**CITY OF DEXTER
PLANNING COMMISSION
WORK SESSION
MONDAY, MAY 4, 2015**

Re: 3441 Broad Street Special Use Review, plan dated May 4, 2015
Alternative plan A1.01alt and A1.01altB dated, May 27, 2015
Applicant: Craig Borum, Ply Architecture
Project: Strawberry Alarm Clock
Zoning: VR Village Residential

Re: 3441 Broad Street Combined Site Plan Review, plan dated May 4, 2015
 Alternative plan A1.01alt and A1.01altB dated, May 27, 2015
 Applicant: Craig Borum, Ply Architecture
 Project: Strawberry Alarm Clock
 Zoning: VR Village Residential

Regarding: Strawberry Alarm Clock Café
Combined Site Plan - Review No. 1
OHM JN: 0130-15-1011

PROPOSED
ELEVATIONS

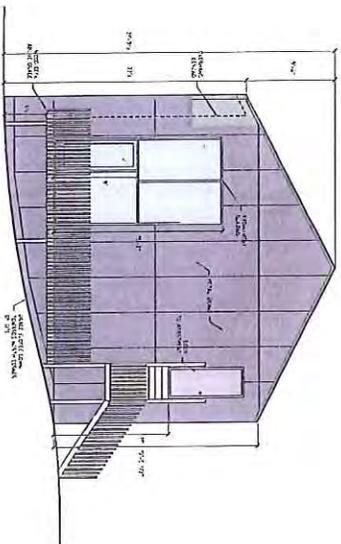
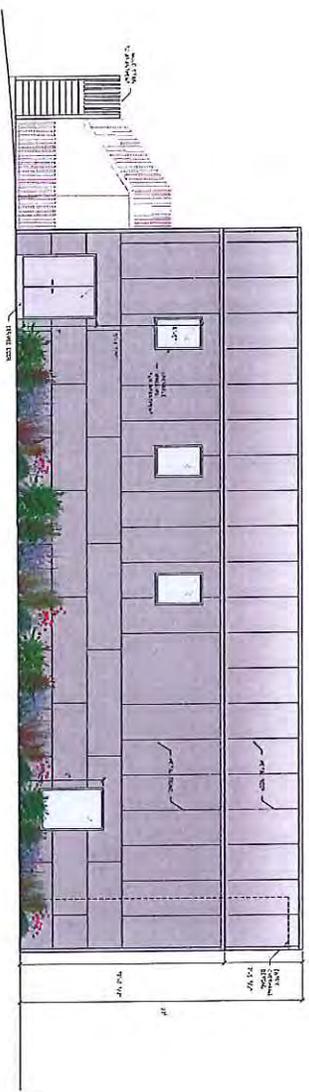
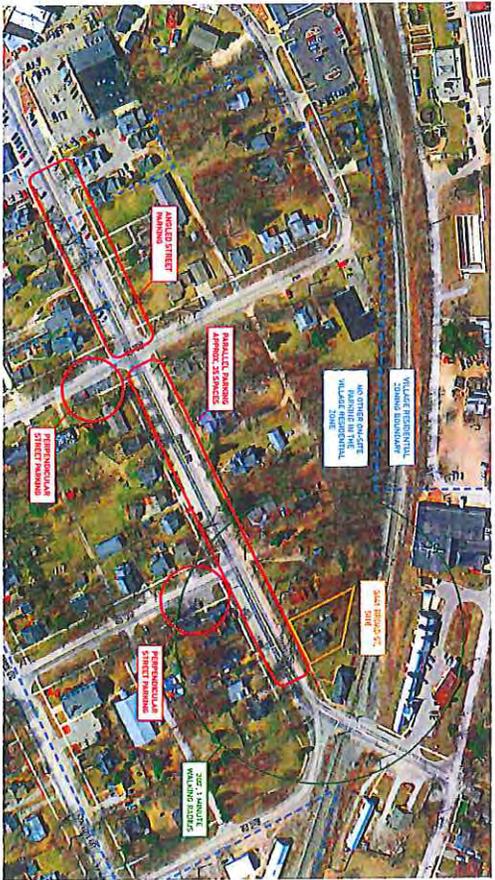
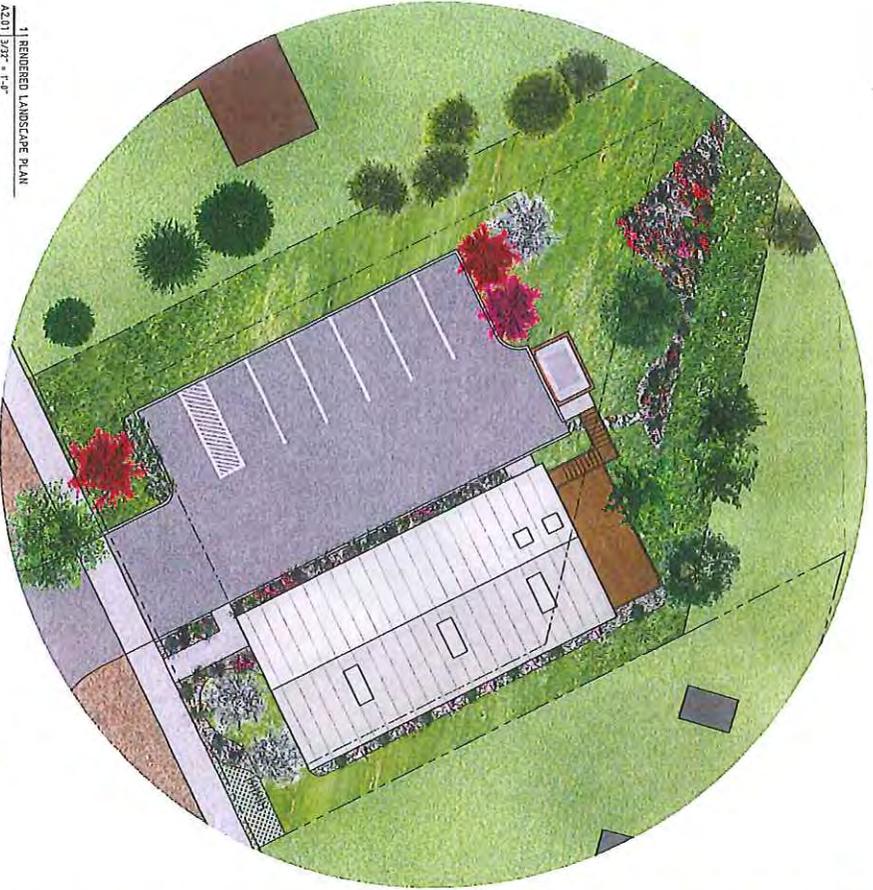
A 25.41 SF wall sign is proposed along the south building elevation. Building signs in the VR district are allowed 0.5 SF for each one (1) foot of building frontage. Based on the 28.83 feet of building frontage the applicant is allowed the maximum 12 SF of wall signage. Information provided on the plan (Sheet A2.00) indicates the square footage of the proposed sign to be 11.8 SF. However, we calculate a 3-foot by 8-foot sign to be 24+ SF in area.

Floor plans and elevations of the proposed structure have been provided. As noted in the special use section of this report, the Planning Commission will need to determine whether the proposed building design is compatible with the surrounding residential neighborhood.

Items to be Addressed: *Planning Commission to consider whether building design is compatible with the existing neighborhood.*

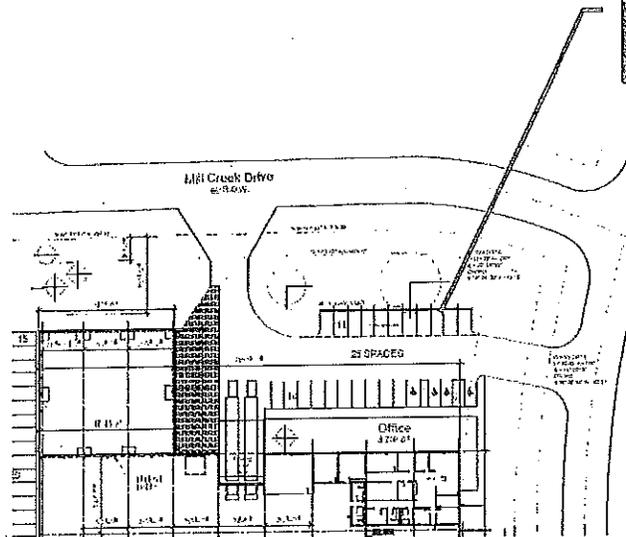
Variety Die and Stamping is proposing a 7,458 SF addition at 2221 Bishop Circle East. The proposed addition would result in the loss of 19 parking spaces; however the proposed site plan provides 24 new parking spaces (NET 5 parking spaces). Approximately 4 of the new parking spaces would be located at the northeast corner of the property; adjacent to the intersection of Mill Creek Drive and Bishop Circle East, and would encroach approximately 4 feet into the required 50-foot front yard setback.

The applicant is requesting the Planning Commission’s approval to permit the construction of the parking spaces within the required front yard setback, in accordance with Section 5.01A of the Zoning Ordinance.

The applicant is requesting the approval of the encroachment in order to maintain a consistent parking lot layout and due to existing loading docks and parking lot circulation needs. The applicant would also like to gain as many parking spaces as possible due to potential future growth.
